**Comments on responses to ExQ2 and Comments on any further information and submissions
received at Deadline 4**

by Anne Heard Interested Party reference 20054475

A. Comments on response to ExQ2 by Springwell REP4-049

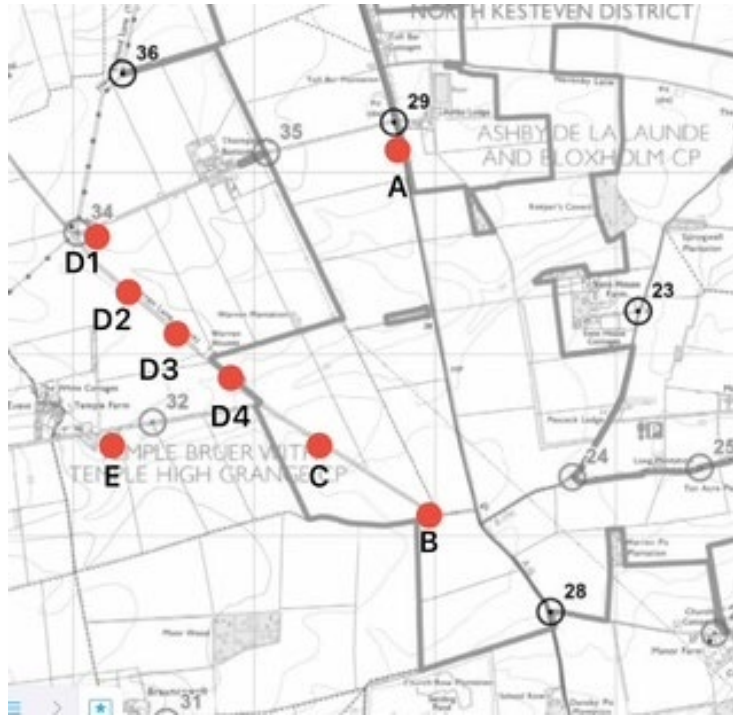
1. The Applicant refers to Viewpoints B and C of the report being taken from field entrances and not being representative of views from Warren Lane. These photographs do not purport to show views from Warren Lane, they are taken along Temple Road, off the junction with the A15 heading towards Temple Bruer. An extract of Chapter 10 Fig 10.4 (APP-066) shows the Applicant's viewpoint locations, including viewpoint 29 (which is Viewpoint A of the report) with Viewpoints B, C, D1, D2, D3, D4 and E of the report also marked on for ease of reference:-

Viewpoints B and C were not taken from field entrances, they were taken from areas of no hedge or very low hedging along Temple Road.

2. The Applicant says that Viewpoints D1-4 and E would have solar arrays behind the viewer when looking towards Temple Bruer. The purpose of these photographs was to illustrate the views of the Temple Bruer Preceptory Church tower along the various public roads around the site. As you walk along Warren Lane between points D1 to D4 the experience would be that on one side of the way would be views across the fields towards Temple Bruer as shown on the photographs whilst to the other side would be fields of solar arrays.
